PCN Number: 1319
Chgnot.doc rev. 13 1/14

Product/Process Change Notification (PCN)

Customer: Newark

Summary description of change: Part Change:

Package Outline Comparison

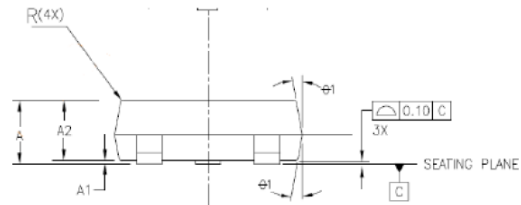
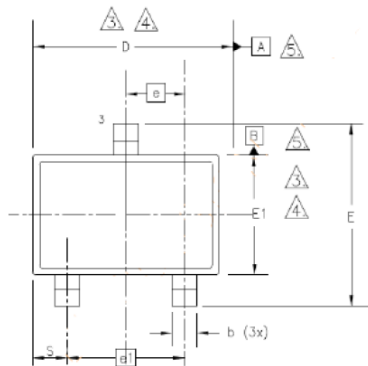
OLD

NEW

Min	Nom	Max	Min	Nom	Max
A	0.87	1	1.13	0.87	1	1.13
A1	0	0.05	0.15	0	0.05	0.15
b	0.3	0.4	0.5	0.3	0.4	0.5
c	0.127	0.18	0.2	0.127	0.18	0.2
D	2.895	2.975	3.1	2.9	2.975	3.1
E	2.7	2.9	3.0	2.7	2.9	3.0
E1	1.85	1.91	2.1	1.85	1.91	2.1
e		0.95			0.95 bsc	
e1		1.90 bsc			1.90 bsc	
AAD	0.24	0.28	0.32	0.24	0.28	0.32
S		0.55 Ref			0.55 Ref	
R				0.05	0.15	0.2
Foot Angle	0	4	8	0		8
Draft Angle		10 ref		10	12	14

New Top Brand

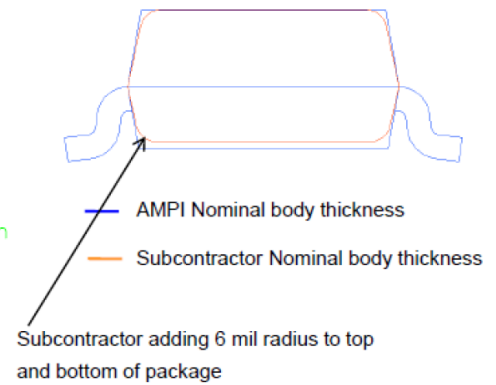
Please see attached picture of top brand for the Subcontractor and new AMPI high-density (HD) assembled SOT-23W package

- Old: Last two digits of the part number + Temperature range designator (ex. 20L)
- New: Last three digits of the part number (ex. 220)

Old Top Brand

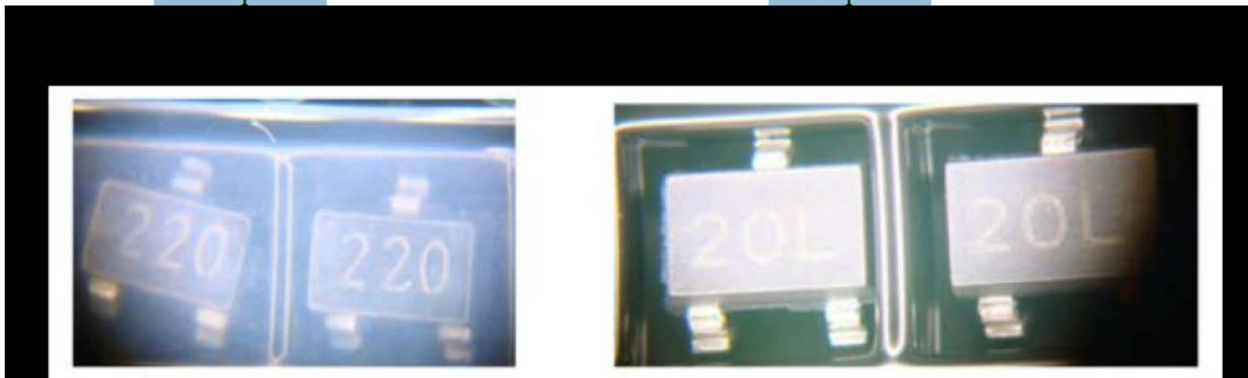
Please see attached picture of top brand for the existing AMPI assembled SOT-23W package.
